ATTACHMENT TO WNP-2 CYCLE 3 RELOAD SUMMARY REPORT

TECHNICAL SPECIFICATION CHANGES

~~ENG-XN-1 Fuel~~
 Figure 3.2.1-3
 ANF 8x8 RELOAD FUEL

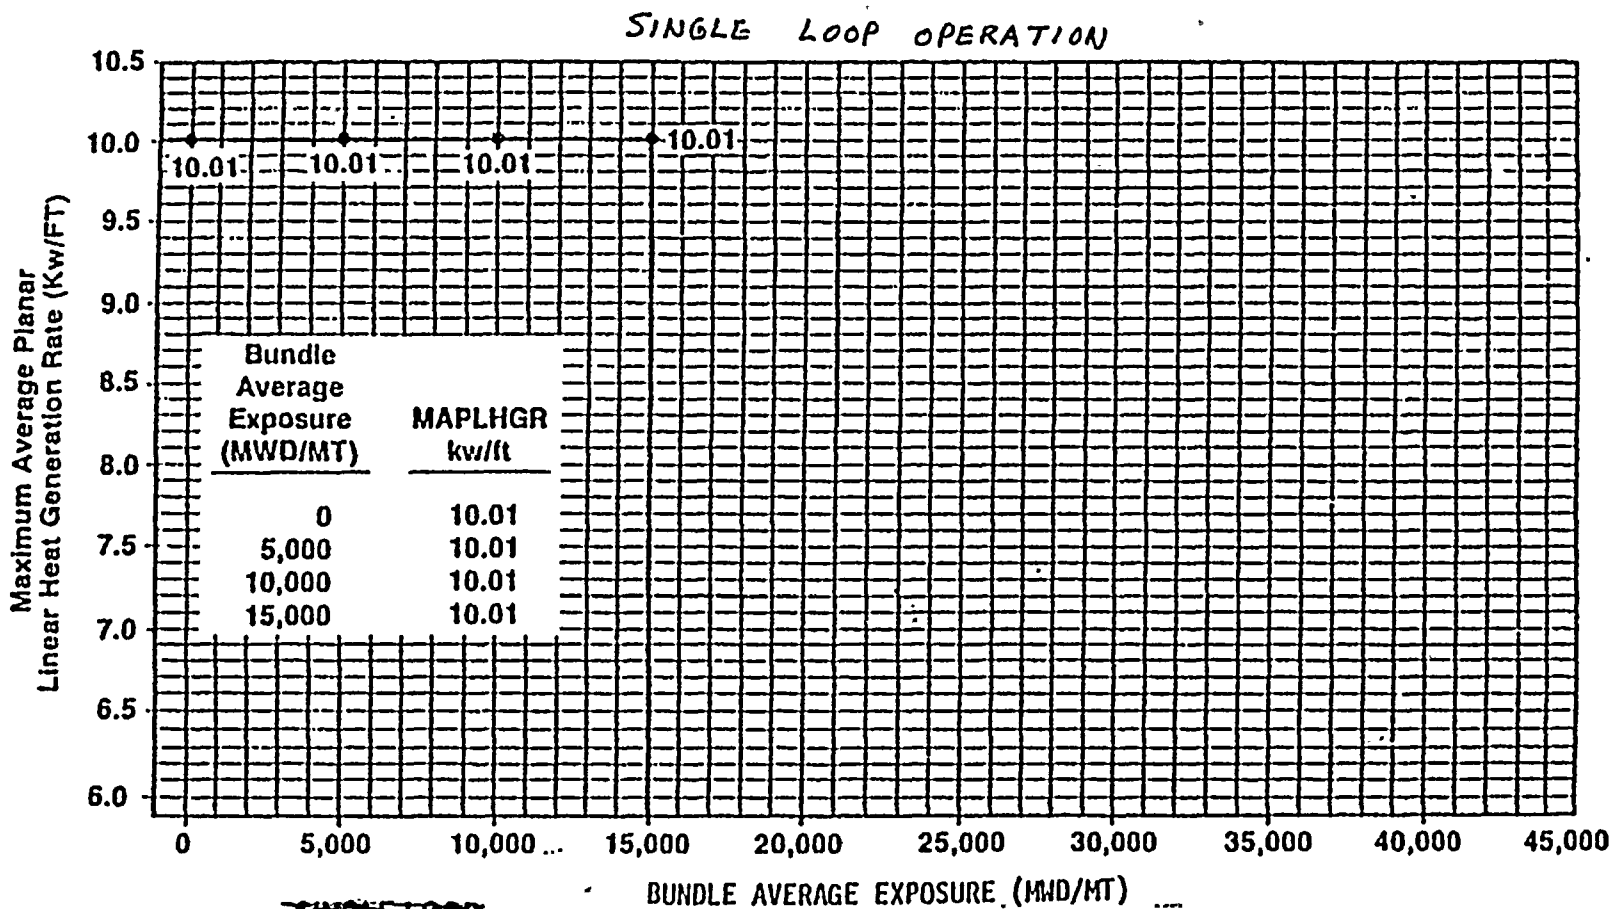
3.2.1 All AVERAGE PLANAR LINEAR HEAT GENERATION RATES (APLHGRs) for each type of fuel as a function of AVERAGE PLANAR EXPOSURE for GE fuel and average bundle exposure for ~~GE~~ fuel shall not exceed the limits shown in Figures 3.2.1-1, 3.2.1-2, and 3.2.1-3x ~~when in two loop operation, and~~ ^{the limits for single loop operation are shown in} Figures 3.2.1-4, 3.2.1-5, and 3.2.1-6x ~~when in single loop operation~~

With an APLHGR exceeding the limits of Figure 3.2.1-1, 3.2.1-2, or 3.2.1-3, ^{IN TWO LOOP OPERATION OR} initiate corrective action within 15 minutes and restore APLHGR to within ^{FIGURE 3.2.1-4,} the required limits within 2 hours or reduce THERMAL POWER to less than ^{3.2.1-5, OR 3.2.1-6} 25% of RATED THERMAL POWER within the next 4 hours. ^{IN SINGLE LOOP OPERATION,}

From 8 x 8 Fuel
ANF ↑ RELOAD
Figure 3.2.4-1

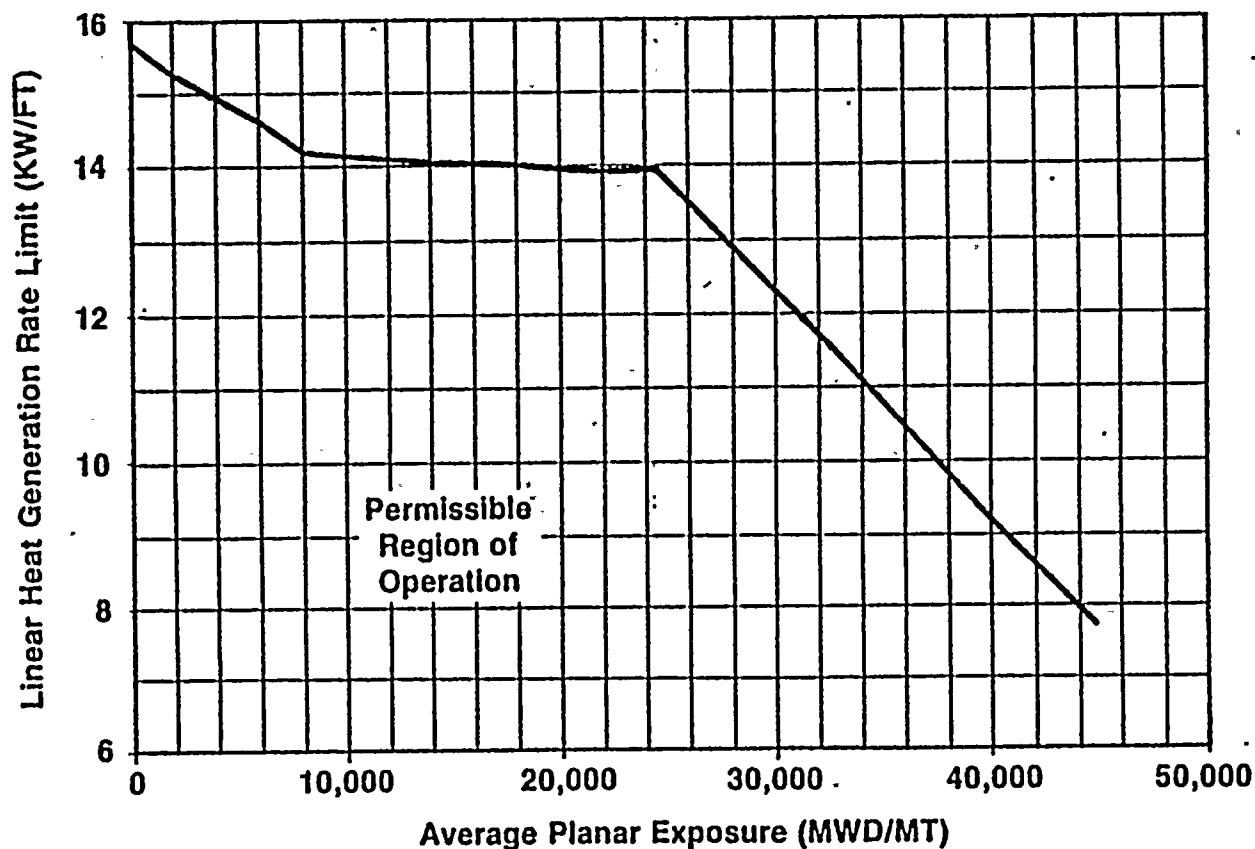
3.2.4 The LINEAR HEAT GENERATION RATE (LHGR) for GE fuel shall not exceed 13.4 kW/ft. The LHGR for ~~GE~~ fuel shall not exceed the values shown in Figure 3.2.4-1.

FIGURE 3.3.10-1

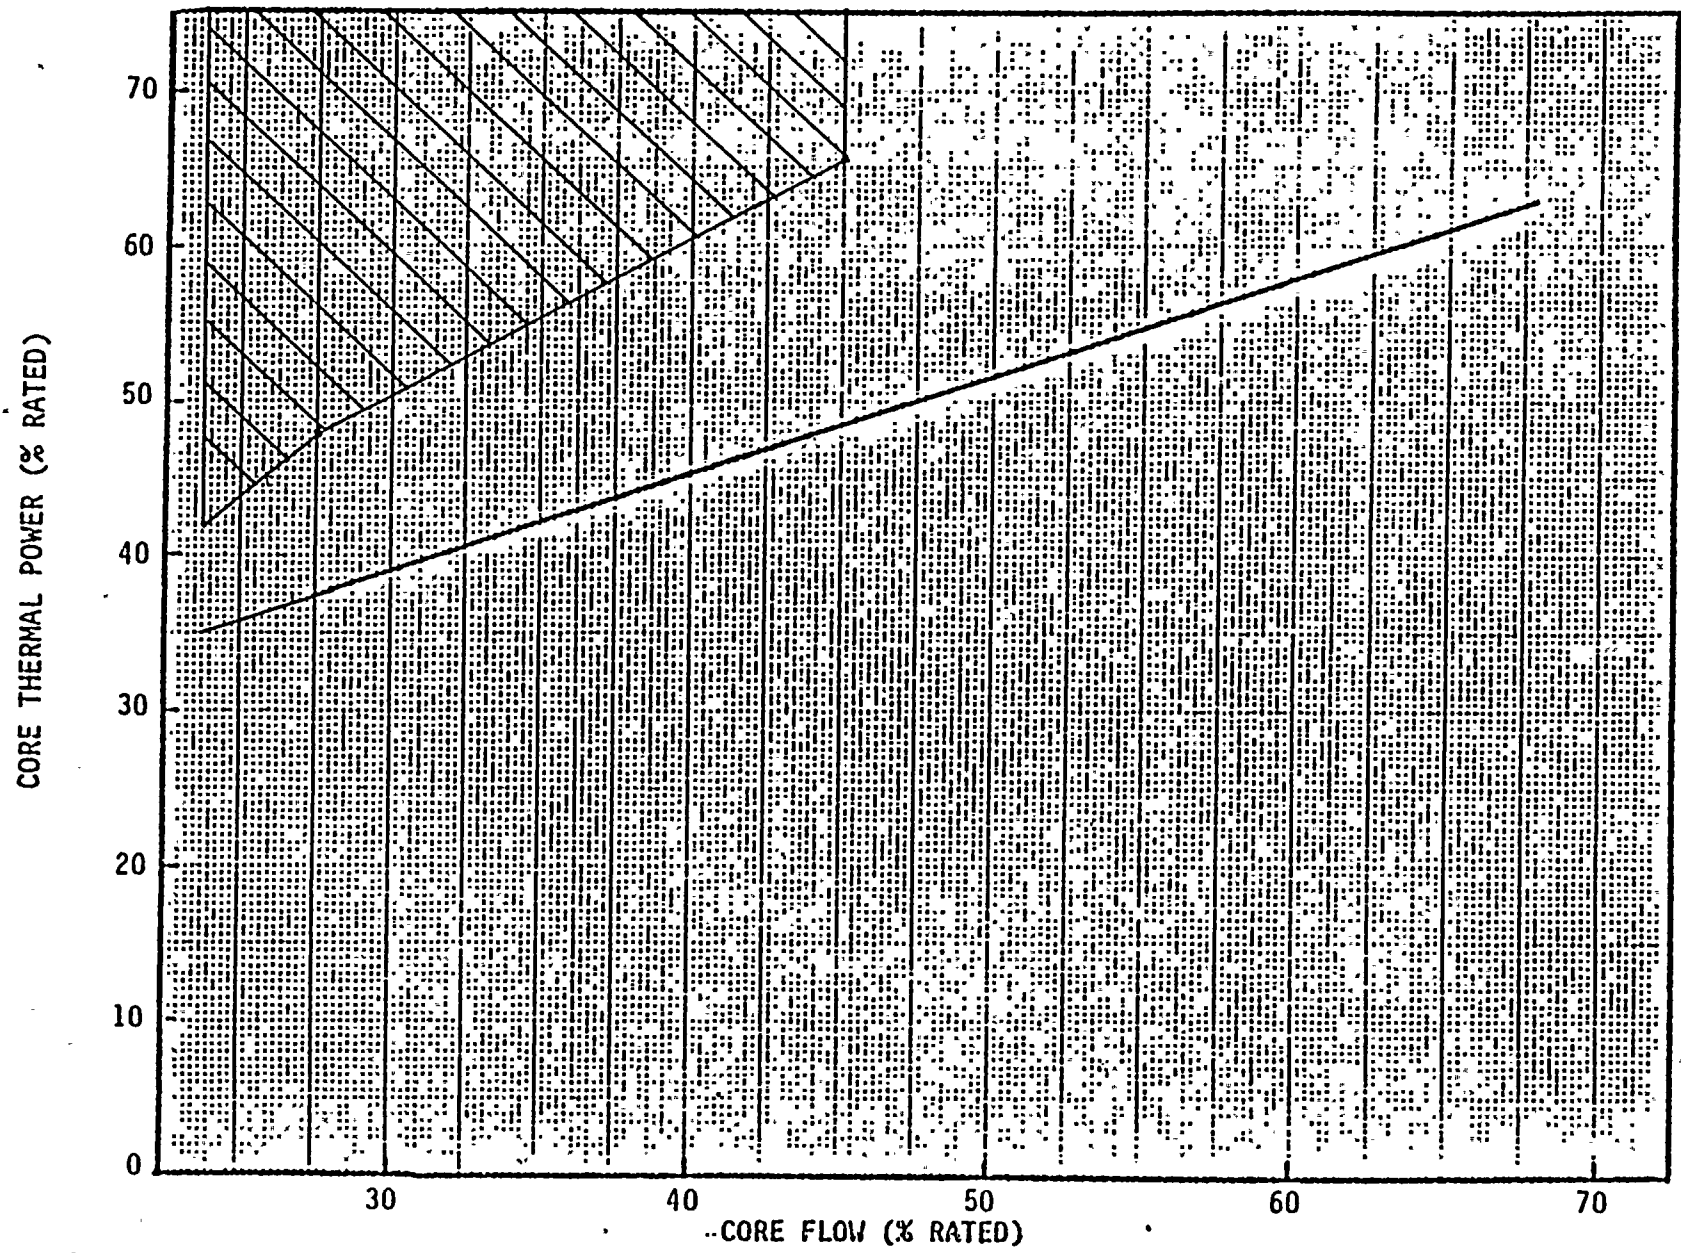
3.3.10 The APRM and LPRM* neutron flux noise levels shall not exceed three (3) times their established baseline values *when operating in the allowable region of Figure 3.3.10-1*

→ *With reactor power/core flow in the cross hatched region of Figure 3.3.10-1 initiate corrective action within 15 minutes to reduce power ^{by} ~~with~~ control rod insertion to a reactor power/core flow below the cross hatched region within 2 hours.*
